Access Compliance Report
Public Rights-of-Way
(Pedestrian Signals)

ADA ID: A5BE11DD4B9C   Signal Type: One Push Button-APS   Overall Compliance: No   Severity Score: BTN 1:N/A   BTN 2: N/A   No BTN: N/A

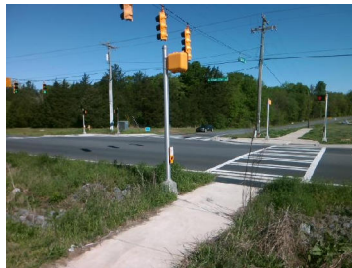
Possible Solutions: Replace Signal Push Button With APS Button on New Post. Remove & Relocate Sign.

PROW/ADA: TMUTCD 4e.08, R406.2, R209.1, MUTCD 4e.10
